B. Final Plat (dated: 9/16/2024)

D. Common Driveway Exhibit (Lots 12, 13 and 14)

VI. CITY/AGENCY COMMENTS & CONDITIONS

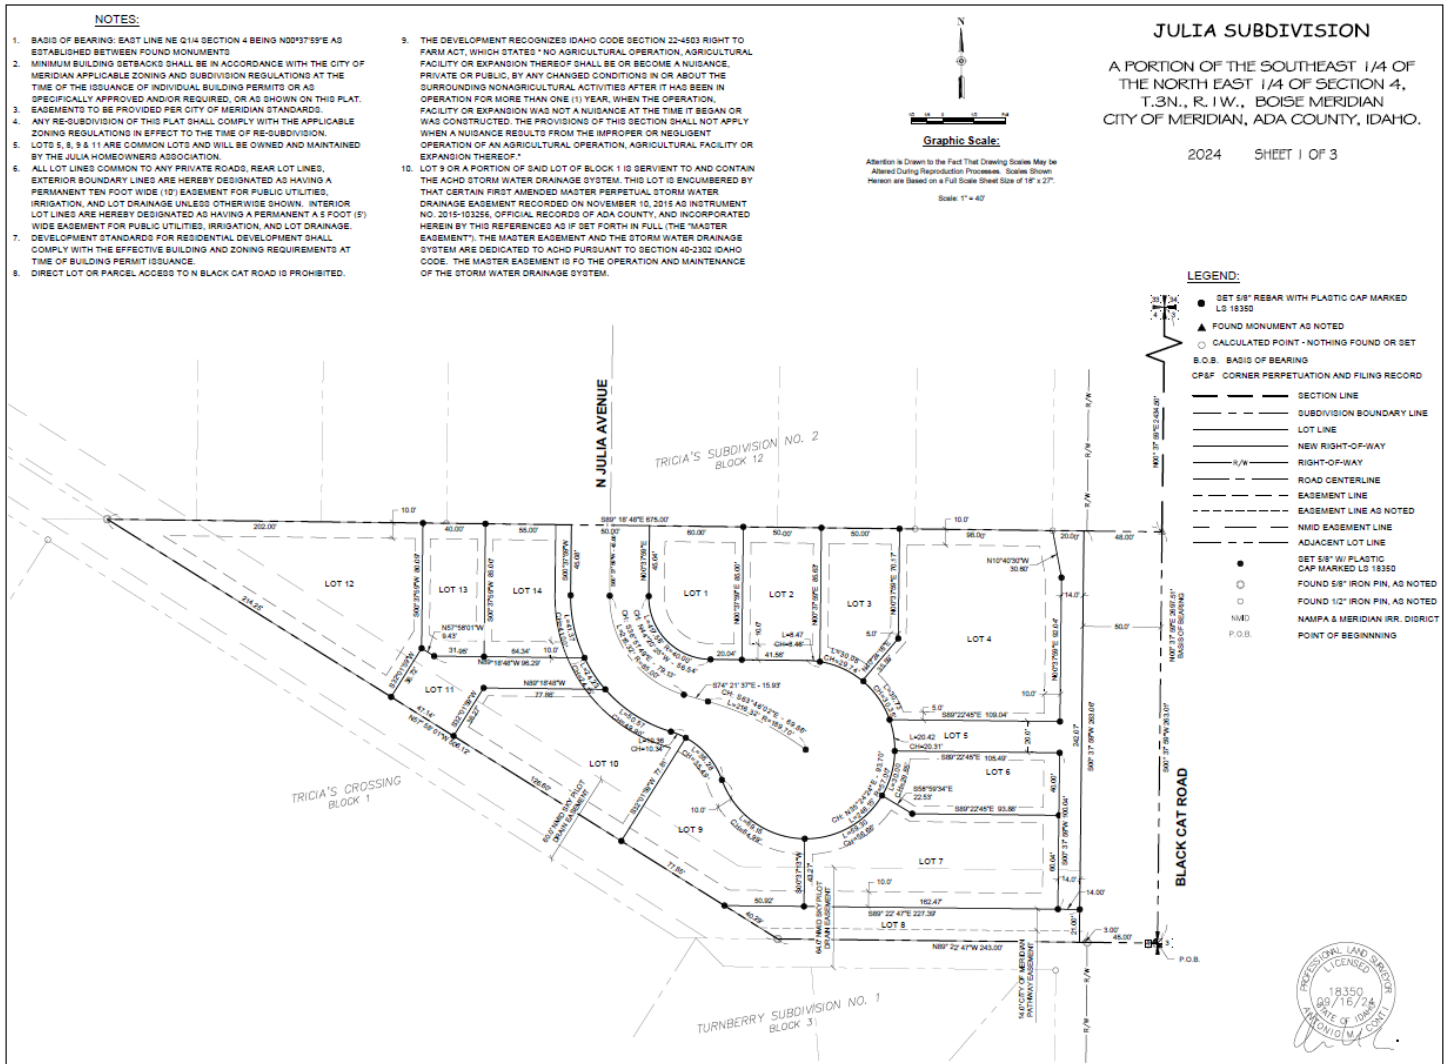
3. Prior to submittal for the City Engineer's signature, have the Certificate of Owners and the accompanying acknowledgement signed and notarized.
4. The final plat prepared by Ackerman Estvold, stamped on 9/16/24 by Antonio Conti, included in Exhibit B shall be revised as follows:

- a. If Lot 5 contains an easement, graphically depict it on the plat along with a recorded instrument number, if applicable.
 - b. Depict 30-foot minimum street frontages for Lots 3, 4 and 6, measured as a *chord* measurement, per UDC 11-2A-3B.1.

- c. Graphically depict and include a note for a perpetual ingress/egress easement for the common driveway on Lot 11 that includes a requirement for maintenance of a paved surface capable of supporting fire vehicles and equipment as set forth in UDC 11-6C-3D8; *or*, record a separate easement/agreement and include a reference to the recorded instrument number on the plat.

- d. Note #2: "Minimum building setbacks shall be in accordance with the City of Meridian applicable zoning and subdivision regulations at the time of issuance of individual building permits ~~or as specifically approved and/or required, or as shown on this plat.~~"

- e. Note #6: "All lot lines common to any ~~private~~ public roads, rear lot lines, exterior boundary lines are hereby designated as having a permanent ten-foot wide (10') easement for public utilities, irrigation, and lot drainage unless otherwise shown. Interior lot lines are hereby designated as having a permanent ~~a~~ 5-foot (5') wide easement for public utilities, irrigation, and lot drainage."

- f. Add a new note: "Lot 8 contains a City of Meridian pedestrian pathway easement, recorded as instrument_____."
 - g. Add a new note: "Lots 7-12 contain a Nampa Meridian Irrigation District easement for the Sky Pilot Drain." Also, include information about the anticipated license agreement with NMID, including the recorded instrument number of the agreement, and the specifics of what is and isn't allowed in the easement area.

- h. Depict a 5-foot wide detached sidewalk along N. Black Cat Rd. as requested by ACHD and agreed up by Planning Staff to match the width of the existing sidewalk to the north & south.

L150

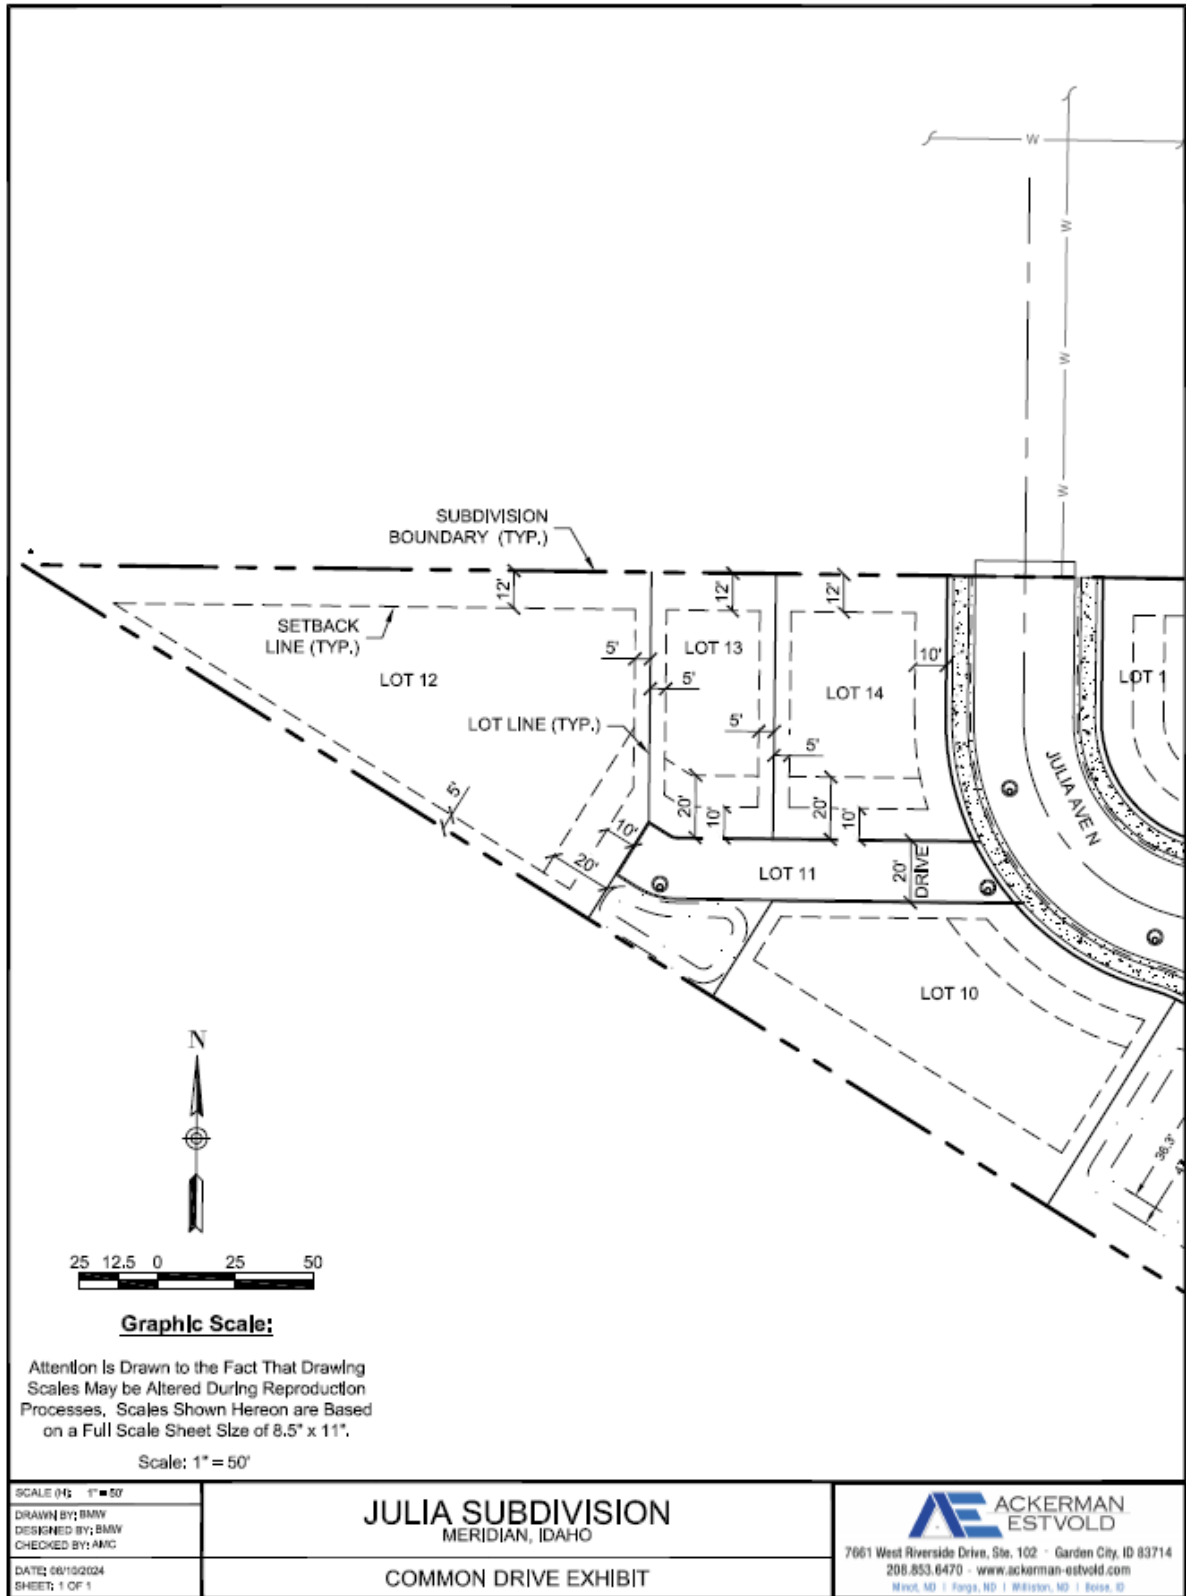
- c. Change the fencing type along the western boundary of the site adjacent to the common open space in Tricia's Crossing subdivision to open vision or semi-private up to 6-feet in height or if closed vision fencing is proposed, it can't exceed 4-feet in height, as set forth in UDC 11-3A-7A.7b.
